LR-N07-0102  
LCR H05-01, Rev. 1  
May 10, 2007

Hope Creek Generating Station  
Facility Operating License No. NPF-57  
NRC Docket No. 50-354

**Subject:** Response to Request for Additional Information  
Request for License Amendment - Extended Power Uprate

**Extended Power Uprate**

**Reactor Assembly Drawing**

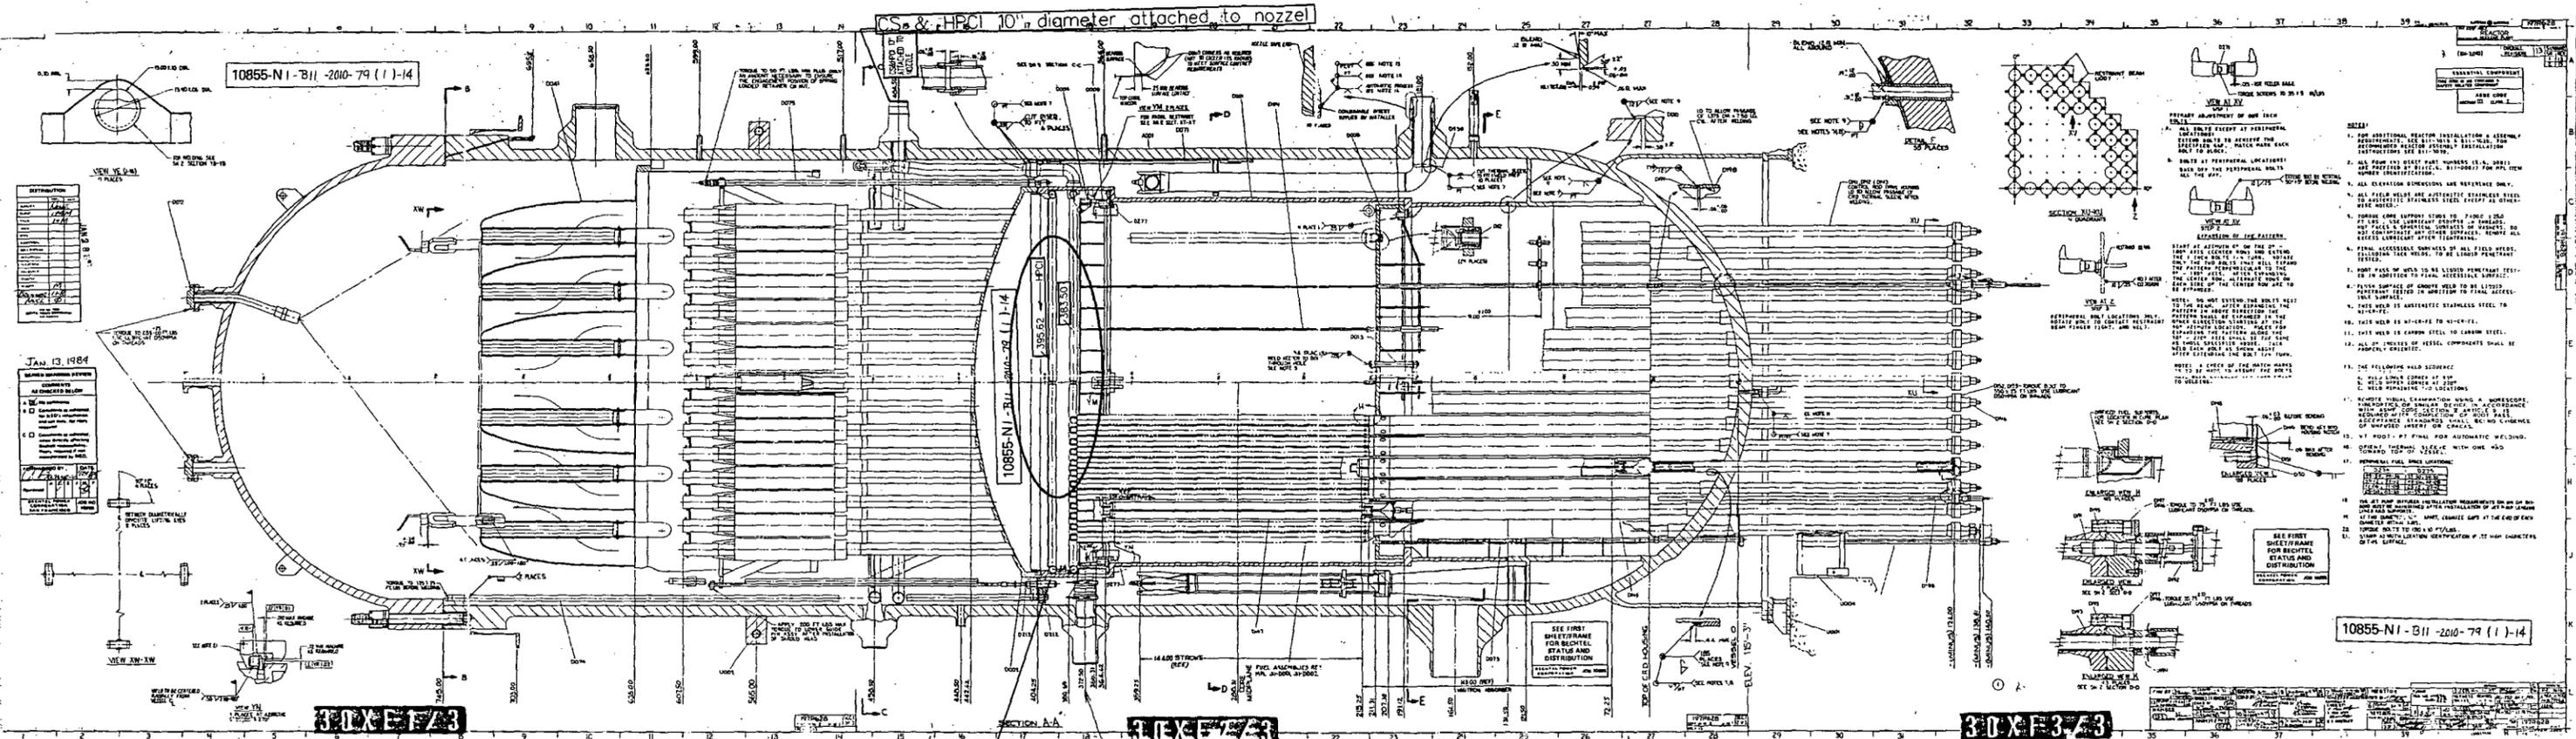
- 3.58 Please provide Hope Creek plant configuration information for the ECCS systems including drawings or diagrams showing the injection points in the reactor vessel for LPCI, HPCI, and core spray (Revised after conference call).

An assembly drawing of the reactor vessel, annotated to show the injection points for LPCI, HPCI and core spray, is attached. The minimum HPCI flow injected through the core spray piping is provided in the response to RAI 3.51.
